PRODUCT UPDATE

Lift Axle Control Kits

LIT NO: P56047

DATE: August 2018

Current Lift Axle Assembly

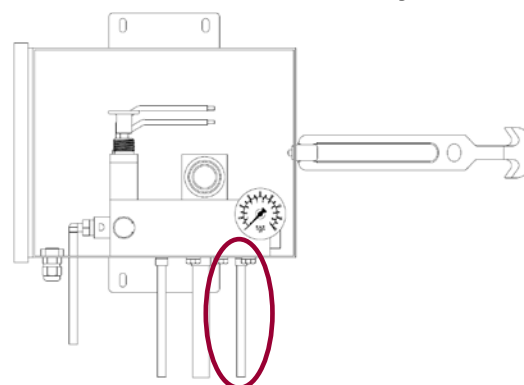
Hendrickson Trailer Commercial Vehicle Systems announces a change to its Lift Axle Control Kits. Beginning in late August 2018, the vent protector will be replaced with a ¼" NPTF barbed tube fitting and ¼" ID tube. This change is being made to commonize parts within the assembly. The barbed tube fitting and tube will be shipped loose and require installation.

The vent protector aftermarket replacement part number, VS-31819, will no longer be available. It is replaced by VS-24580 barbed tube fitting and VS-24581 ¼" ID tube.
